**Addendum to the  
Freeport Regional Water Project  
Final Environmental Impact Report  
State Clearinghouse No. 2002032132**

**Freeport Regional Water Authority**  
Sacramento County Water Agency  
East Bay Municipal Utility District

April 2006

**Figure 1**  
**Revised Pipeline Alignments**  
**from the Freeport Intake Facility to the**  
**Zone 40 Surface Water Treatment Plant and Folsom South Canal**

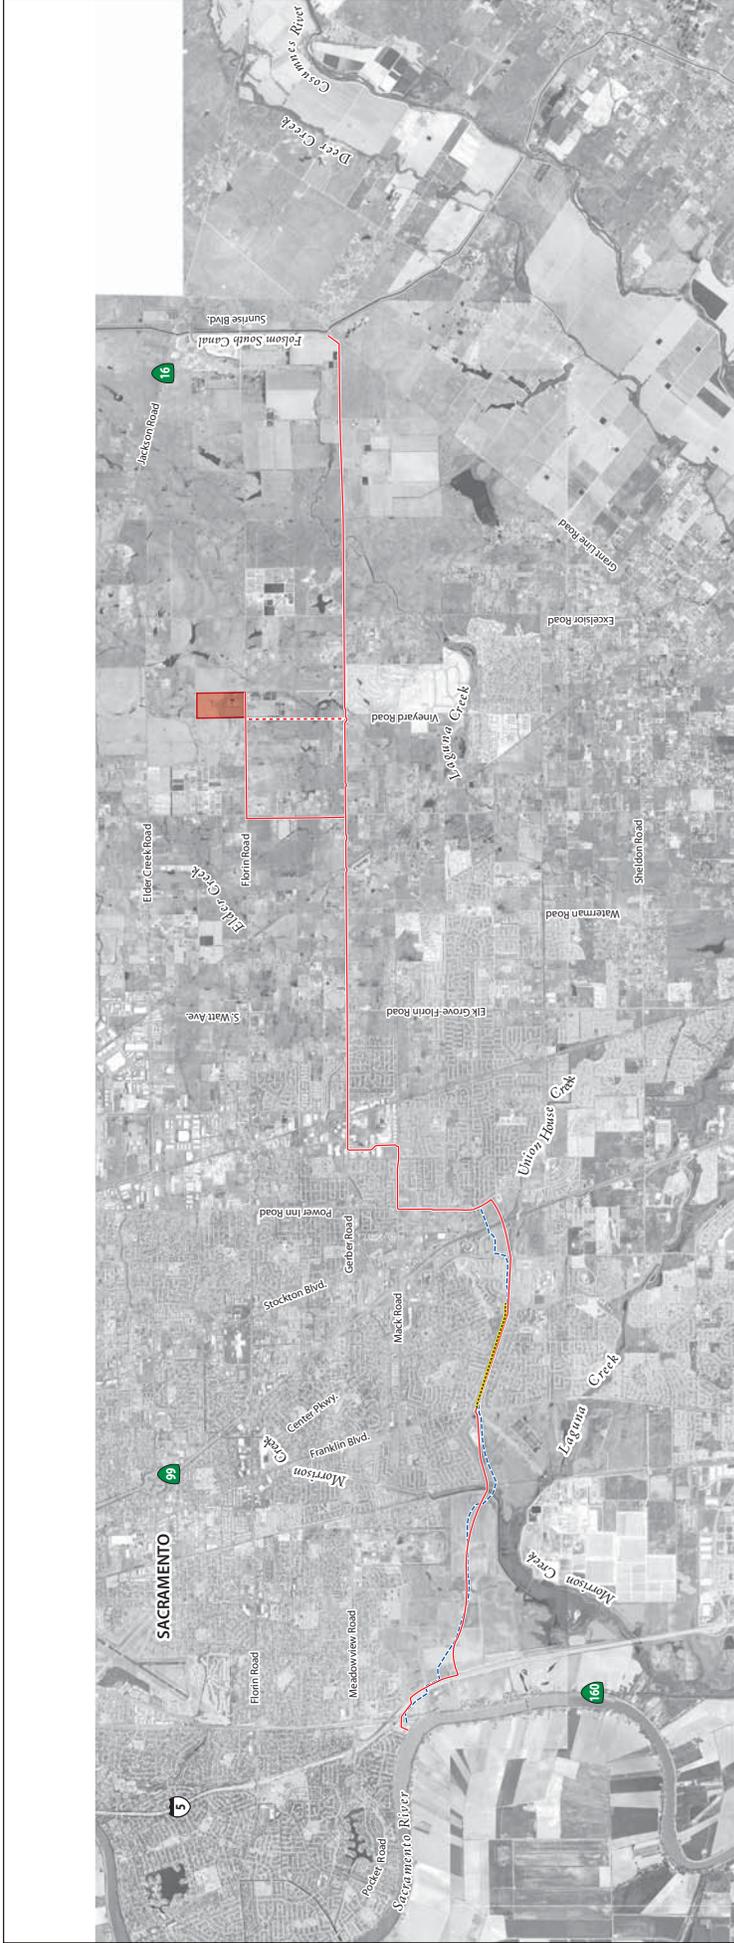
As shown in Figure 1, the FRWA alignment runs from the intake facility at the Sacramento River to its terminus at the FSC. It connects to the turnout for the Zone 40 SWTP near the intersection of Gerber Road and Bradshaw Road. The turnout extends to the SWTP while the main pipeline continues to the FSC.

Modifications to the pipeline diameter have been made in two locations. For the pipeline turnout to the Zone 40 SWTP, the original 60-inch-diameter pipeline will be increased to 66 inches. For the pipeline continuing beyond the turnout to the FSC, the original 66-inch-diameter pipeline will be increased to 72 inches. These changes were made to increase the energy efficiency of the pipeline. A 66-inch pipe and 72-inch pipe will decrease energy costs for pumping and have lower life-cycle costs than a 60-inch pipe and 66-inch pipe, respectively. These modifications will not require any changes to the 130-foot-wide right-of-way needed for all pipeline alignments discussed in the Adopted FRWP EIR. The 130-foot-wide right-of-way consists of a 40-foot-wide permanent operation corridor, 90-foot-wide temporary construction corridor, and a 7-foot trench from ground level to the top of the pipe. The total trench depth will average 15-feet with a trench width of 12- to 14-feet. While there are some pipeline segments that will not require a full 130-foot-wide right-of-way (the in-road segments of the joint pipeline and the Folsom South Canal Connection [FSCC] segments in particular), that width is used consistently for purposes of this analysis.

To assist with the flow of traffic in an urban area, FRWA has decided to construct a temporary bypass road in one specific location. The temporary bypass road will be constructed from Franklin Boulevard to 800 feet east of Center Parkway parallel to Cosumnes River Boulevard to reduce traffic impacts during the pipeline construction. It will use existing Franklin Boulevard and Center Parkway intersections. (Figure 1)

The adjoining turnout, or raw water pipeline, to the Zone 40 SWTP will be modified. The alignment of the 66-inch pipeline will now travel east on Gerber Road and then north, following the proposed Vineyard Road Extension to the SWTP. The effects of this modification are analyzed in an Initial Study/Negative Declaration for the Zone 40 Central Surface and Groundwater Treatment Plant, Pipelines, and Corporation Yard by the Sacramento County Department of Environmental Assessment and Review.

**Figure 3**  
**Pole Antenna**

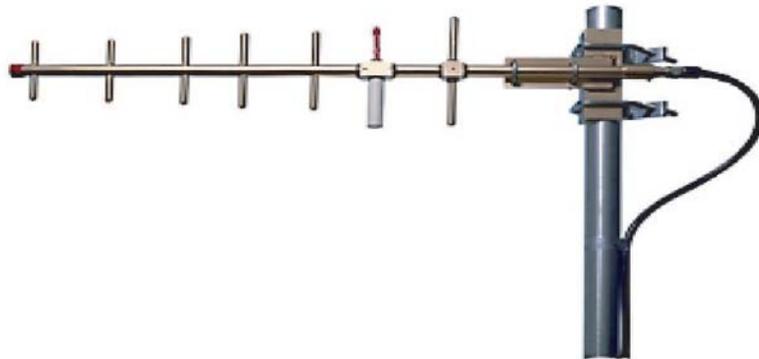
Both omnidirectional (ability to boost signal in more than one direction) and unidirectional antennas will be required for the FRWP. Both antenna types are available in compact and visually inconspicuous shapes, sizes, and colors. The locations that require communication in multiple directions (repeater sites) will likely use pole antennae very similar to the one shown in Figure 3. Antenna length will be about 10 feet.

**Figure 6**  
**Aqueduct Pumping Plant Facilities**

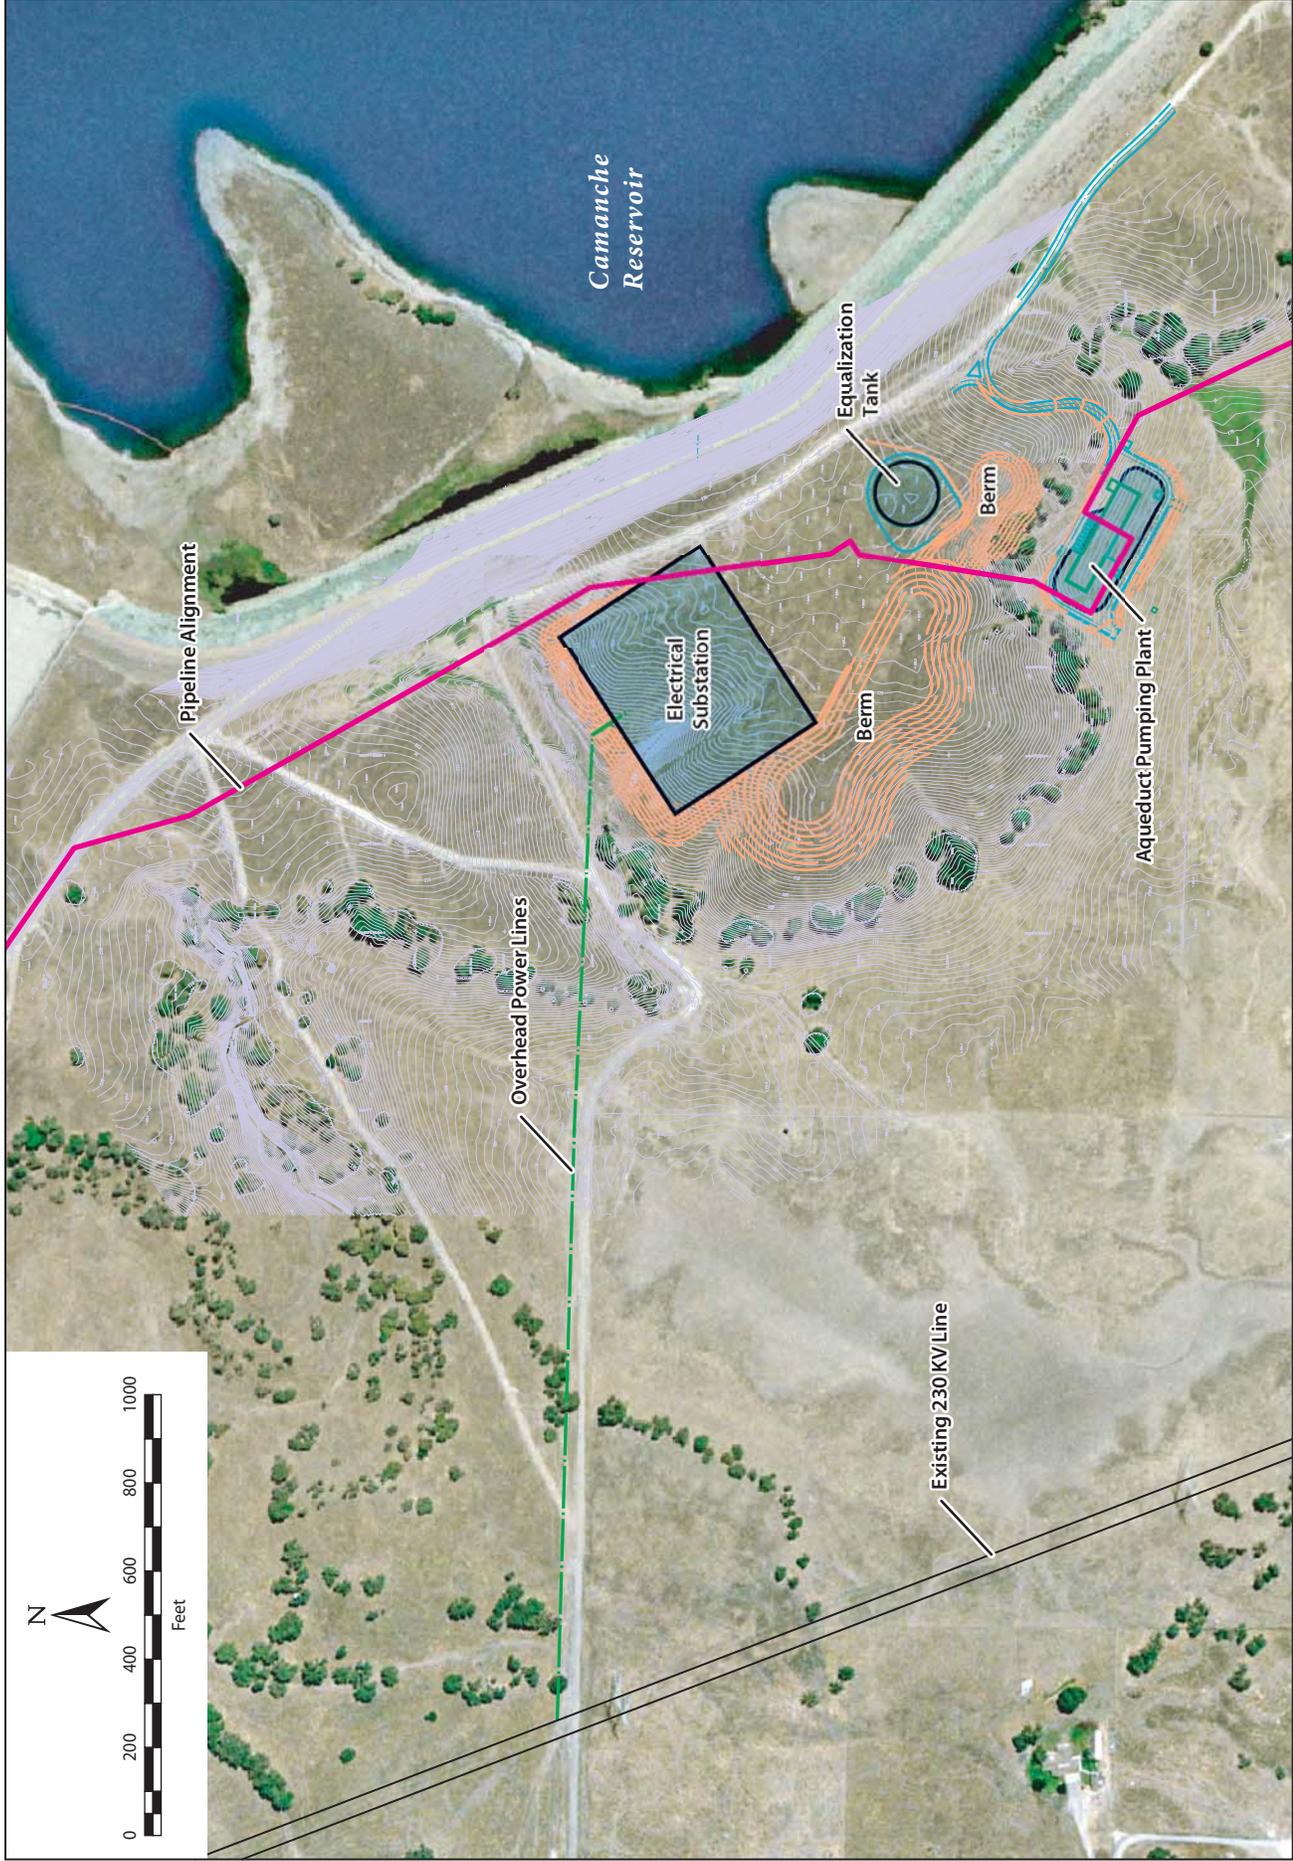
The electrical substation site at the Aqueduct Pumping Plant was detailed on Figure 2-13 in the Adopted FRWP EIR document. The size of the electrical substation has increased to accommodate the equipment required to meet all of the present and future power needs. The location has also changed to provide the lowest overall cost and fewest technical issues, minimize aesthetic concerns, minimize impacts to wetlands, and provide the most room for future expansion, if needed. Figure 6 shows the location of facilities near the Camanche Reservoir.

In addition to the change in the size and location of the electrical substation, the size of the electrical cable bussing structure at the substation also has been increased. The cable bussing structure may reach heights of 100 feet above ground. This height is needed to meet the National Electrical Safety Code and allow the most compact design of the substation.

It is anticipated that excavation of the FSCC pipe alignment will require chemical blasting from station 77500 to station 80350 near Camanche Reservoir Dam (Figure 6). The noise and vibration effects of blasting were not specifically analyzed for this location in the Adopted FRWP EIR, but the effects of excavation and pile driving near Pardee Dam resulting in similar effects were analyzed and discussed. The results of the Pardee Dam analysis are similar to the proposed blasting near Camanche Reservoir Dam and are adequate for purposes of this analysis.
